Summerlin West Village 27

Technical Drainage Study for Lake Mead Boulevard

Comment Response Letter

RE: Update #1 Addendum #1 to the Technical Drainage Study for Lake Mead Boulevard (Street Y to Mountain Run Drive) and Street Y (Street Z to Lake Mead Boulevard)

XXXXXX	DESIGNED BY: B. MOCHITTAK
CLV L22-00626	DRAWN BY: K. HENDRY
DATE: MAY, 2022	CHECKED BY: N. BARCOS
DRAWING NO.	HORIZ.: 1"=20' VERT.: N/A
	13/29

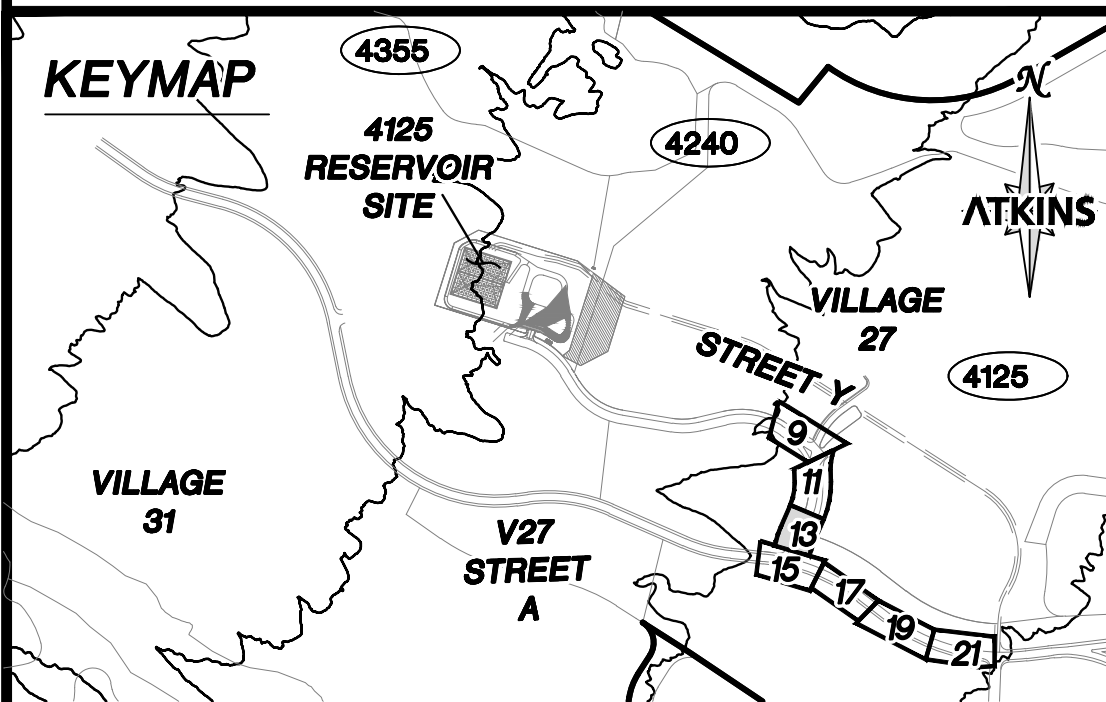
Comment #5: All offsite interim flood control facilities such as but not limited to berms/ditches and temporary sumps are privately owned and to be privately maintained by the Howard Hughes Company. Provide a note as such on the grading plans.

Comment response: The note was shown on the included grading plans from the Technical Drainage Study Update #1 and are attached for convenience. Example shown on Sheet 13 attached.
